Inspection of Automatic Sprinkler System

Martinrea SA BE2 East London Industrial
Development Zone

UNC8482

Photo 5

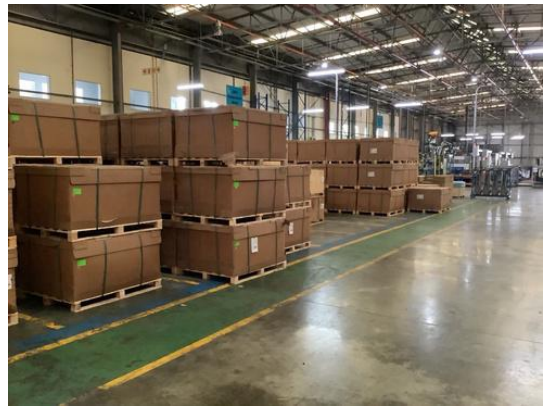
Free Standing Block Storage and aisle widths are not being maintained.

No block of storage shall exceed 150 m² of floor area and shall be surrounded by aisle widths of not less than 2,4 m.
